## **ROACH 2 REV 2 UPDATES**

- Most changes involve isolating the 3V3 and 3V3AUX devices to prevent backpowering.
- Splitting of I2C Bus between the 3V3 and 3V3AUX devices.
- 6.8mm Battery Holder replaced with a CR2032 (20mm) Battery holder.
- Crystal oscillator (for PPC) replaced with a clock oscillator.
- Additional PPC LED and redesigned LED layout.
- Some ZDOK data lines have been swapped around.
- JTAG Isolation.
- Redesigned "POWER OVERRIDE" AND "AUTO START" circuits.
- Full list of changes can be found in the Roach 2 pre-production readiness Document.

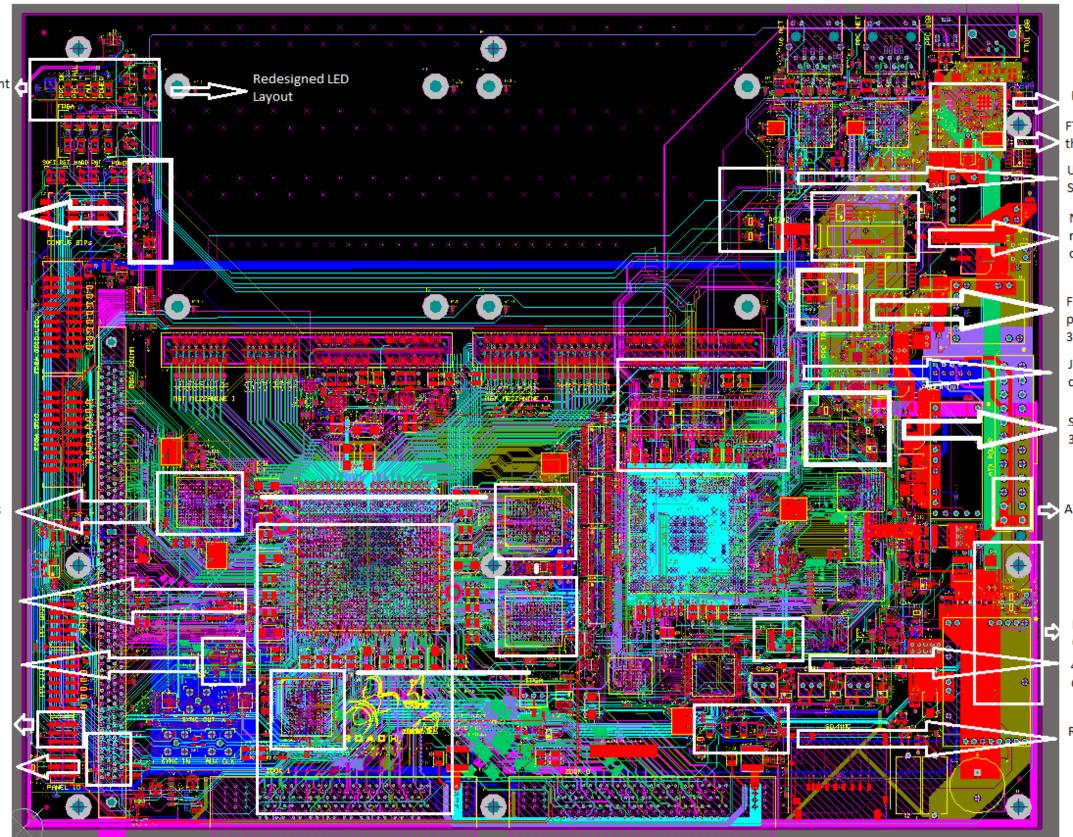
Fault\_LEDn latched to
ATX\_PWR\_OK to prevent
it operating during
standby

Splice ATX\_PG into SYS\_PORn

QDR (U57 U58,U60,U61) ODT range resistors added and 10K pull-ups on pins P6,A1 and A11

ZDOK pairs swapped on FPGA

THS3061 replaced with THS3091

PPC GPIO added for PPC FAIL LED DDR SPD Addresses

set to 110

FTDI\_CTRL resistors

FTDI\_TDI & FTDI\_TRST buffered through U82

U31 & U83 changed to Switches (UARTO)

New battery holder and revised oscillator/RTC circuit

Fault pull-ups (R68,69,70,71) pulled up to 3V3 not 3V3AUX

JTAG Isolation. OEn connected to ATX\_PGn

Split I2C Bus between 3V3 and 3V3AUX devices

ATX Pin 13 to 3V3MON

New Circuitry for JP1 (Power Override) and JP2 (Auto Start) 48Mhz Clock replaces Oscillator

Redesigned LED Layout
